**Re: R.M. of St. Francois Xavier Wastewater Treatment Lagoon Expansion -
Environment Act Proposal**

**RE: R.M. OF ST. FRANCOIS XAVIER – WASTEWATER TREATMENT LAGOON
EXPANSION - ENVIRONMENT ACT PROPOSAL – REVIEW RESPONSE**

1. **Memorandum from Manitoba Conservation and Water Stewardship – Water Quality Management Section, dated March 11, 2013.**

PROPOSED DISCHARGE ROUTE
 C04

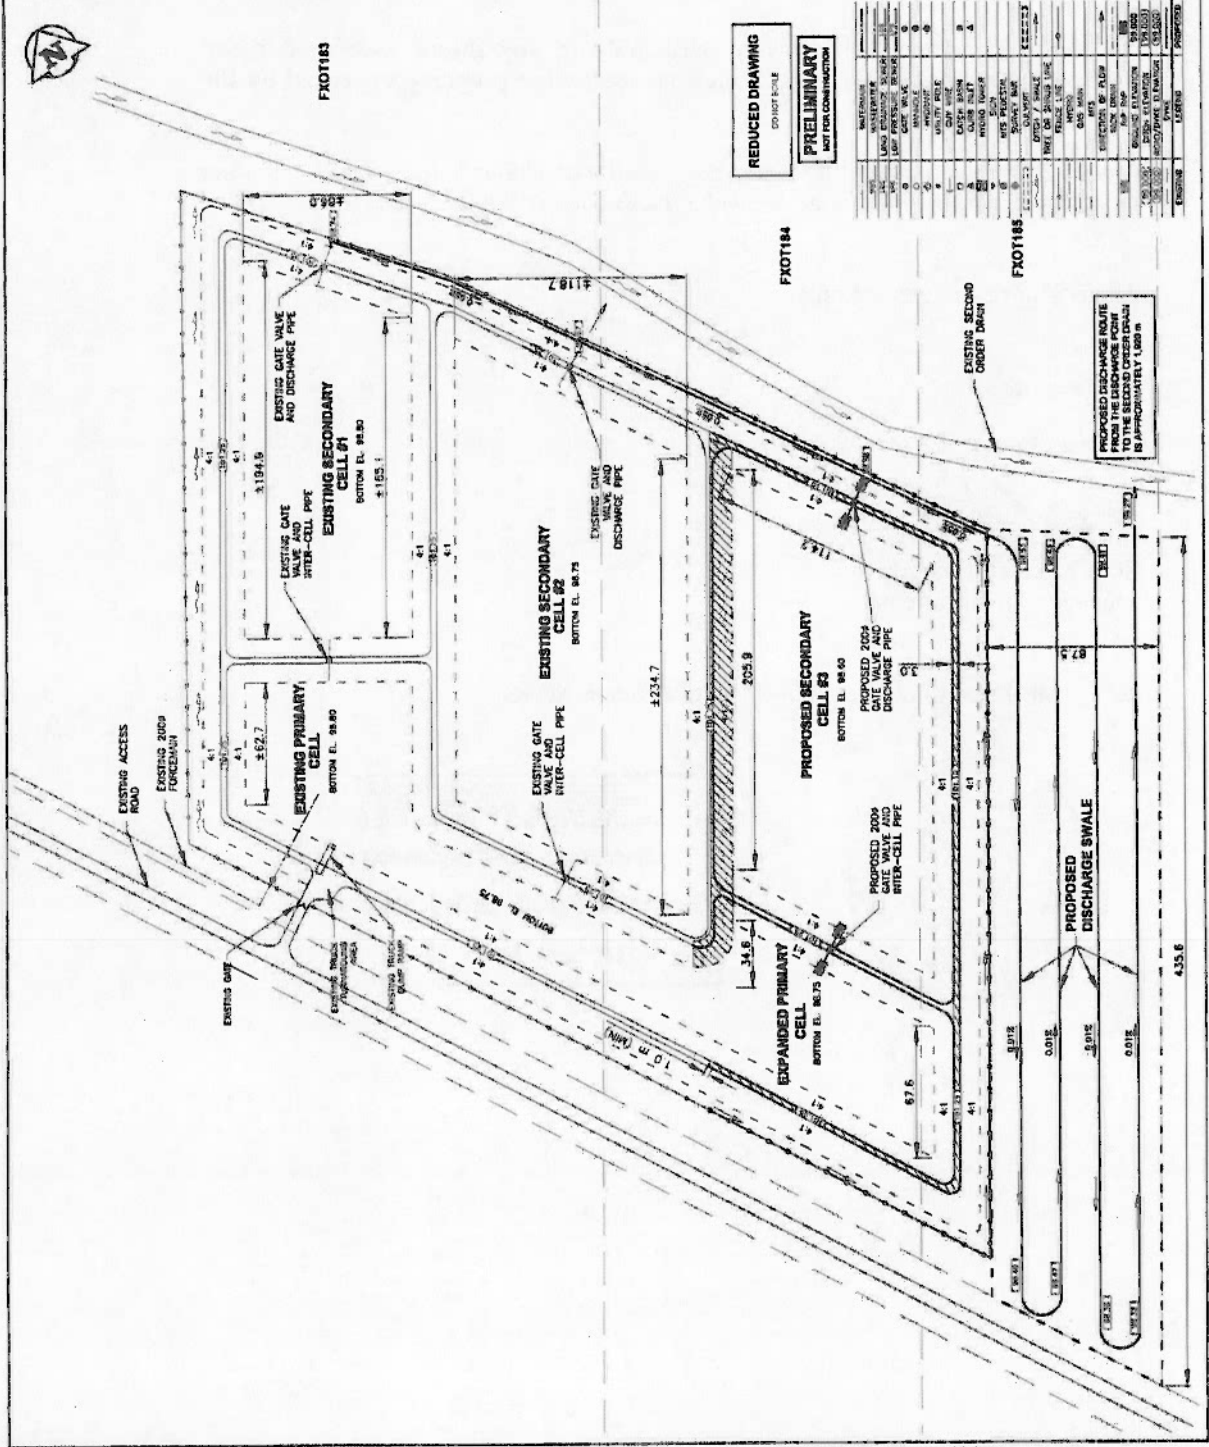
.1 The effluent standards should not allow discharge where the total phosphorus content of the effluent is in excess of 1 milligram per litre or provide additional information on the equivalency of trickle discharge to a 1 mg/L phosphorus limit. This information must be provided before trickle discharge can be approved as a nutrient reduction strategy.

The existing R.M. of St. Francois Xavier lagoon services the existing R.M. of St. Francois Xavier population of 1,240 people. The R.M. of St. Francois Xavier is expecting a population increase of 600 people over the next 20-year period for a total 2032 population of 1,840, which is less than 2,000. Therefore, to meet the requirements of the Water Quality Standards, Objectives and Guidelines Regulation under The Water Protection Act (2011), the R.M. of St. Francois Xavier proposed to implement a nutrient reduction strategy consisting of a trickle discharge. That portion of the discharge route, between the discharge point and the existing second order drain, has been reviewed and it is now proposed to extend it by creating the serpentine flow discharge swale to the south of the proposed secondary cell, and now averages approximately 1,920 metres (See the attached drawing). The distance of the route from the discharge point of the proposed lagoon to the Assiniboine River with proposed extension is approximately 11,000 metres. A trickle discharge extending from two to four weeks will allow the vegetation and the soil in the bottom of the discharge ditch, swale and the existing secondary drain to absorb nutrients and reduce the nutrient load to the Assiniboine River.

We have checked into previous studies and reports we have done on lagoons. The typical phosphorus concentration in the effluent is usually 2-3 mg/L. In the past, we had the opportunity to monitor the flow in the discharge ditch of a lagoon where the phosphorus reduction in 1,400 metres of flow in the discharge ditch was 35 percent. That would translate into 48 percent reduction in 1,920 metres. It is expected that reduction of the final phosphorus concentration in the effluent from the R.M. of St. Francois Xavier lagoon would be about 0.96-1.44 mg/l by the time it reaches the existing second order drain. The absorption of nutrients will be continued in the existing second order drain, and by the time it reaches the Assiniboine River the phosphorus concentration is expected to be less than 1 mg/l. The proposed discharge swale will be seeded with grass. The grass cover will be mowed periodically and baled.
